# Review Assessment

South Florida Water Management District's  
Central Everglades Planning Project, Section 203  
Post Authorization Change Report, Integrated  
Feasibility Study and DRAFT Environmental Impact  
Statement  
(March 2018, Amended May 2018)

May 2018

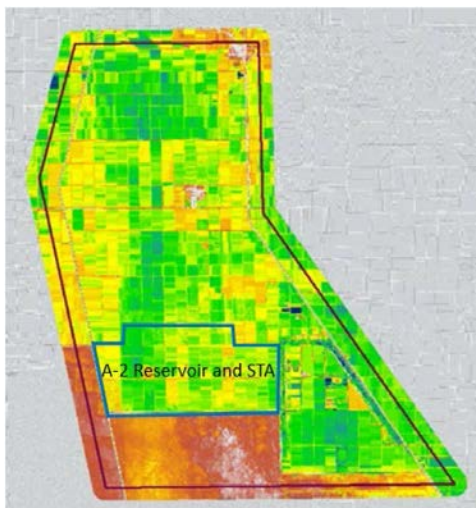
Recommendation for Resolution. A consequence assessment needs to be performed for the proposed water impoundment measures included in the TSP (A-2 Reservoir). The results of the consequence assessment need to be included in the evaluation of the alternative to allow decision makers to determine if the risks of the alternative are tolerable to achieve the proposed project benefits. This includes the communication of the risks to any potentially affected community.

At least a summary of the consequence analysis should appear in the main report and discussion of the TSP. The full results of the consequence analysis should be included in an appendix (likely Appendix E). From ER 1110-2-1156: “Consequences are defined as potential life loss, economic damages, and environmental damages. At the minimum estimate the consequences related to failure of the dam from a breach of the dam with the reservoir at the maximum pool – no spillway discharge, maximum pool with full spillway discharge, and overtopping of the dam.”

SFWMD Response: A concise “consequences assessment” for failure of the proposed A-2 Reservoir is included in Section A.5.1 (Hazard Classification and Emergency Evacuation Requirements) of Appendix A of the CEPP PACR. SFWMD provides the following additional details for your information.

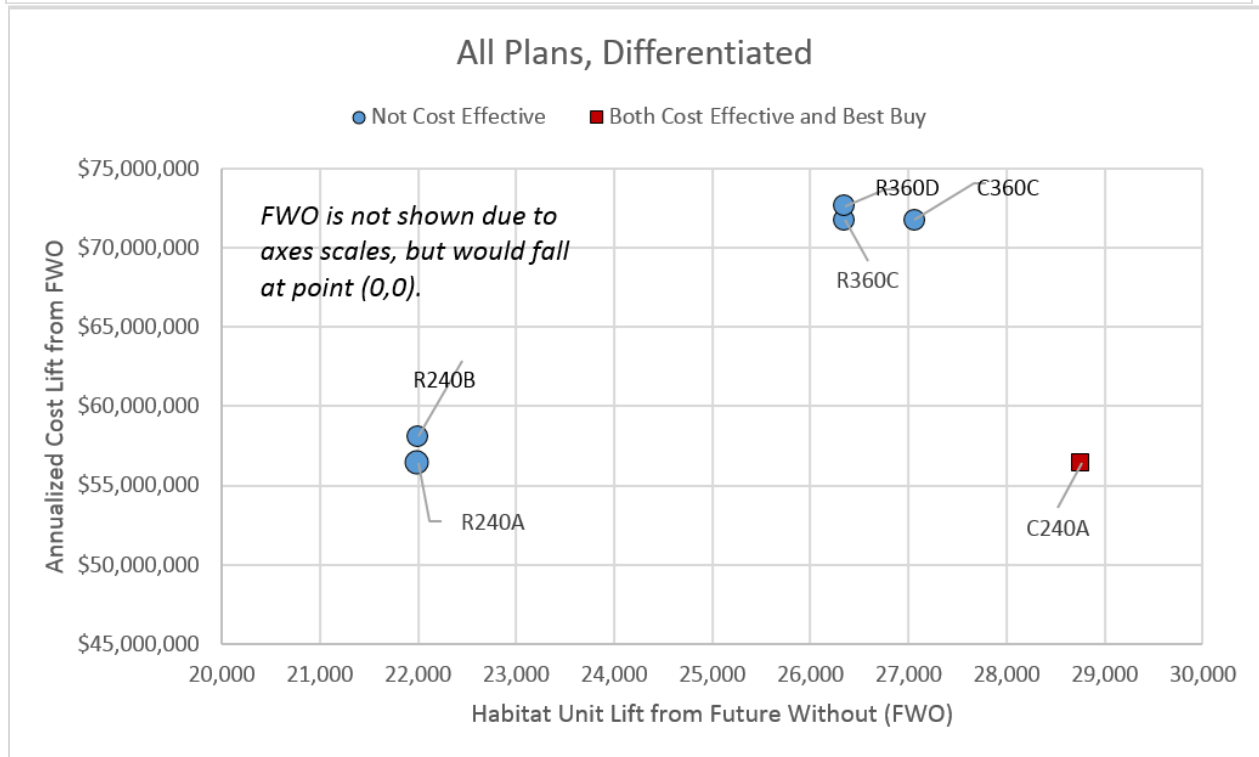
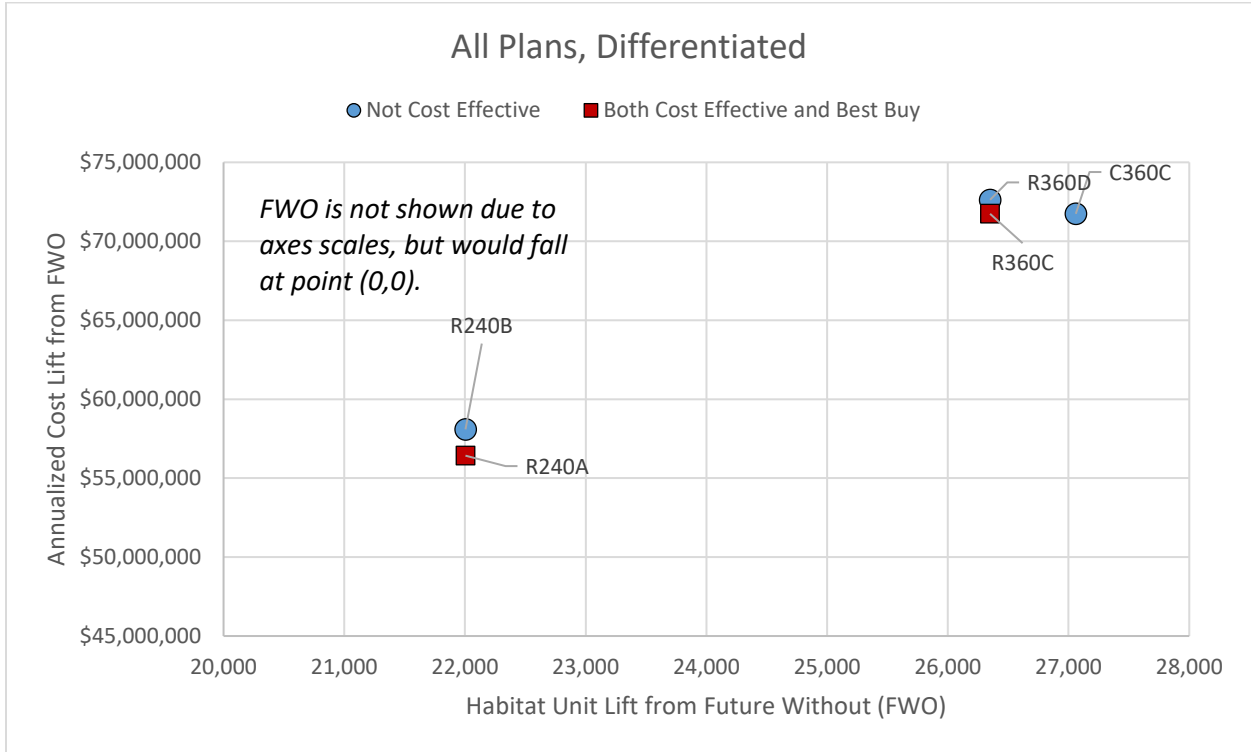
X. CE/ICA Graphic. The results of CE/ICA are not shown graphically. While the overall results shown in Section 4.2.3 and Tables 4-9 and 4-10 appear to be calculated and presented correctly, the cost effectiveness and incremental cost analyses should also be portrayed graphically to aid in decision-making and justification of the TSP.

Basis for Concern. ER 105-2-100, E-36. C. (7) states: "Step 7. The final step in the CE/ICA process is to tabulate and graph the incremental costs. (a) It is not necessary to display all such iterations in ecosystem restoration report documentation. What should be provided, however, is a table that summarizes the pertinent incremental cost and output information associated with the increasing size (in terms of output) of the Best Buy plans. (b) Graphing the Best Buy plans can help visually display the relationship between the increasing financial investments required for increasing environmental outputs. Figure E-8 shows the incremental costs of alternative plans (in \$1000) on the y-axis and the average annual environmental benefits (in habitat units) on the x-axis. A similar one should be provided in ecosystem restoration report documentation."
